Form 3160-5
(June 2019)UNITED STATES
DEPARTMENT OF THE INTERIOR
BUREAU OF LAND MANAGEMENTFORM APPROVED
OMB No. 1004-0137
Expires: October 31, 2021**SUNDRY NOTICES AND REPORTS ON WELLS**
Do not use this form for proposals to drill or to re-enter an abandoned well. Use Form 3160-3 (APD) for such proposals.5. Lease Serial No. **NMNM19858**

8. Well Name and No. **HAWK 35 FED/407H**9. API Well No. **30-025-48036**10. Field and Pool or Exploratory Area
RED HILLS/LOWER BONE SPRING11. Country or Parish, State
LEA/NM**12. CHECK THE APPROPRIATE BOX(ES) TO INDICATE NATURE OF NOTICE, REPORT OR OTHER DATA**

EOG respectfully requests an amendment to our approved APD for this well to reflect the following changes:

Hawk 35 Fed 212H (FKA 407H) API #: 30-025-48036

WELL LOCATION AND ACREAGE DEDICATION PLAT

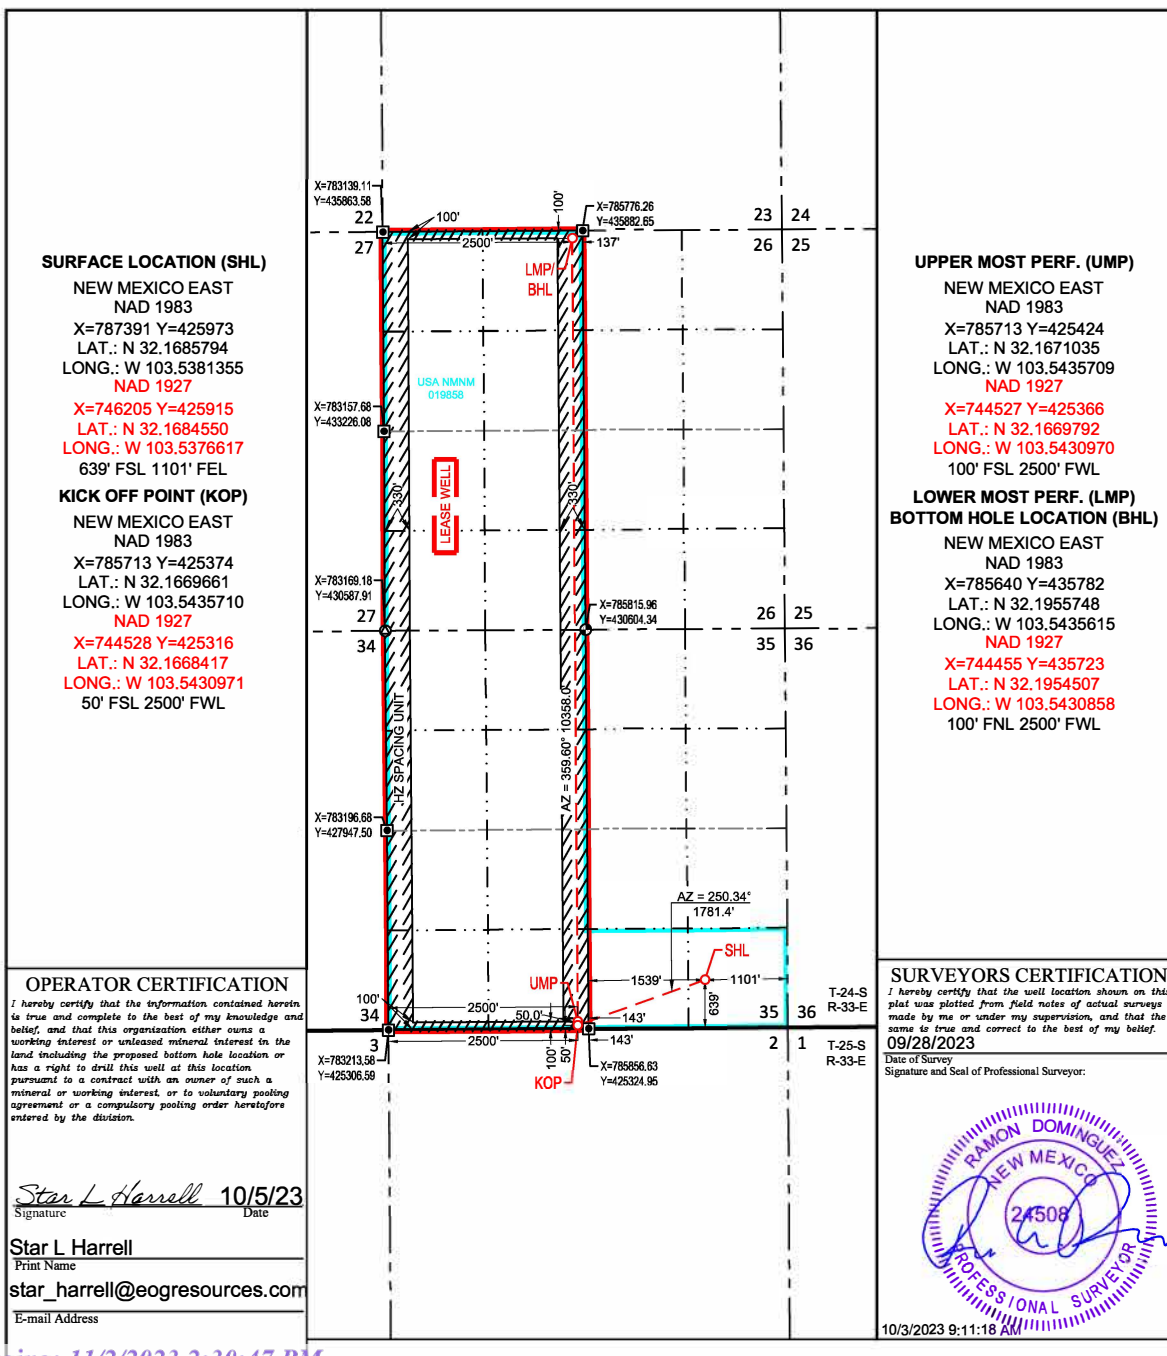
Change name from Hawk 35 Fed 407H to Hawk 35 Fed 212H.

Change BHL from T-24-S, R-33-E, Sec 26, 100' FNL, 680' FEL, Lea Co., NM, to T-24-S, R-33-E, Sec 26, 100' FNL, 2500' FWL, Lea Co., N.M.

Change target formation to Leonard B.

UL or lot no.	Section	Township	Range	Lot Idn	Feet from the	North/South line	Feet from the	East/West line	County
C	26	24-S	33-E	-	100'	NORTH	2500'	WEST	LEA

Proposed 11" Hole with 9.625" 40# J55/HCK55 LTC Casing

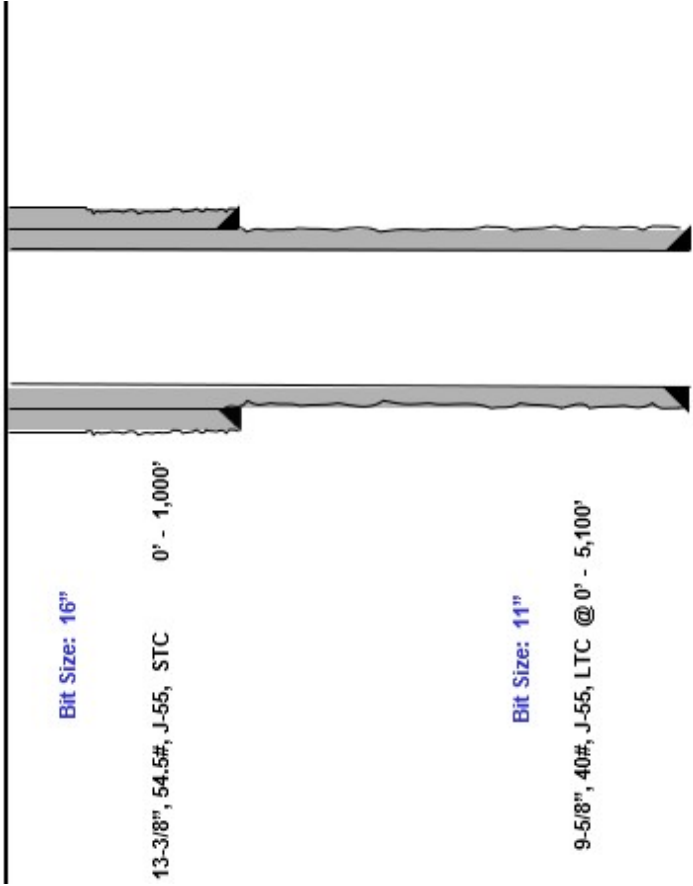
EOG request permission to allow deviation from the 0.422” annulus clearance requirement for the intermediate (salt) section from Onshore Order #2 under the following conditions:

- 11" Bit + 0.52" Average hole enlargement = 11.52" Hole Size
 - 0.9475" Clearance to casing OD
$$= \frac{11.52 - 9.625}{2}$$
 - 0.4475" Clearance to coupling OD
$$= \frac{11.52 - 10.625}{2}$$
- Previous Shoe – 13.375" 54.5# J55 STC
 - 0.995" Clearance to coupling OD (~1,200' overlap)
$$= \frac{12.615 - 10.625}{2}$$
